MCP2551 to MCP2561 Migration

Author: Wilhelm Leichtfried
Microchip Technology Inc.

FIGURE 2: VREF/SPLIT NOT USED, ALWAYS IN NORMAL MODE

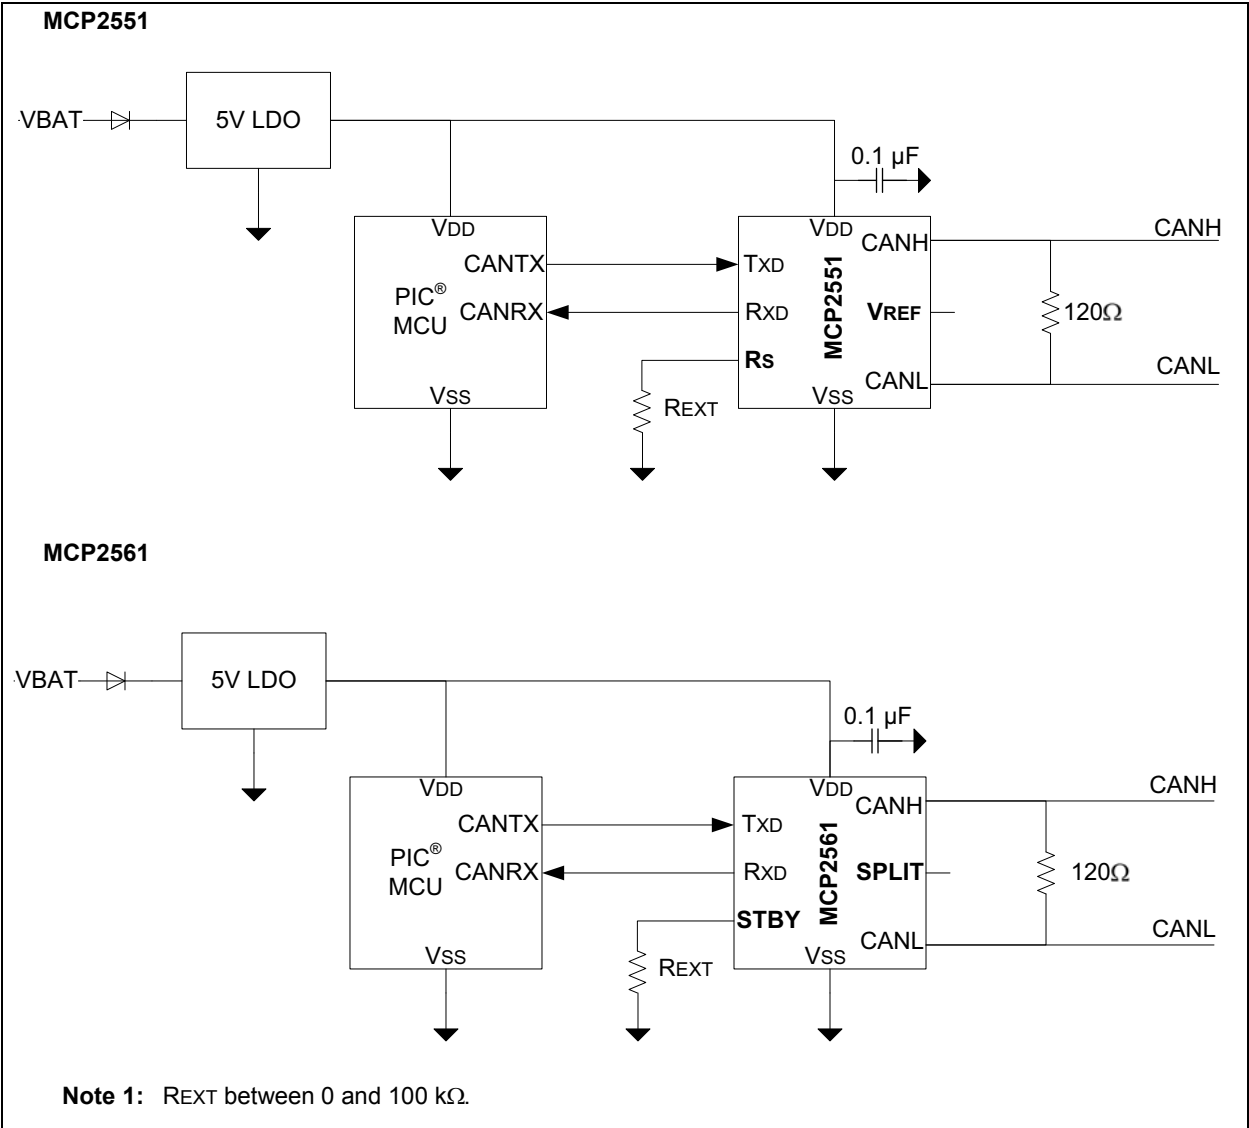
Figure 2 and Figure 3 show two typical applications. The MCP2551 can be replaced with the MCP2561 if the following requirement is met: the **external resistor REXT must be lower than 100 kΩ**.

This document describes the aspects to be taken into account before migrating from the MCP2551 to the MCP2561. The MCP2561 is a direct replacement for the MCP2551. The printed circuit board does not need to be modified. If an external resistor was used on the Rs pin, it has to be lower than 100 kΩ on the STBY pin. The MCP2561 has better EMC performance, lower current consumption and meets all automotive and industrial conformance and hardware requirements.
